Comparison Report

Item	Old 3CC10625MJW CC (10U,25V,X5R,M,0603,WALSIN)	New 3CC10625MJY (10U,25V,X5R,M,0603)
Size (Inch)	**0603**	**0603**
Brend	Walsin	Taiyo
L	1.60±0.20 mm	1.6 +0.20/-0.00 mm
W	0.80±0.20 mm	0.8 +0.20/-0.00 mm
T	0.8±0.20 mm	0.8 +0.20/-0.00 mm
Remark

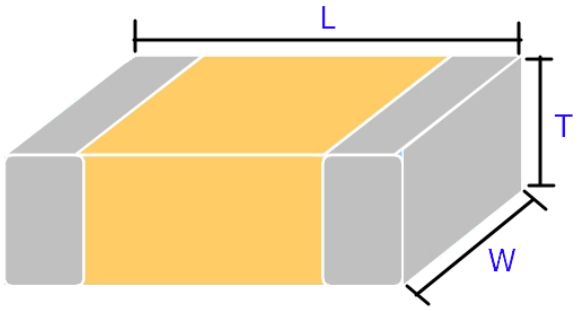
Parameter	(Old)	(New)	Unit
Capacitance	**10**	**10**	**uF**
Rated Voltage	**25**	**25**	**VDC**
Tolerance	**±20**	**±20**	**%**
Dielectric	**X5R**	**X5R**	**-**

This component change has been evaluated by DIVA; the initial successor evaluation showed the new successor is compatible with former model. None of the other components and program will be needed to recalibrate or implement. The ECN will be provided if you approve.
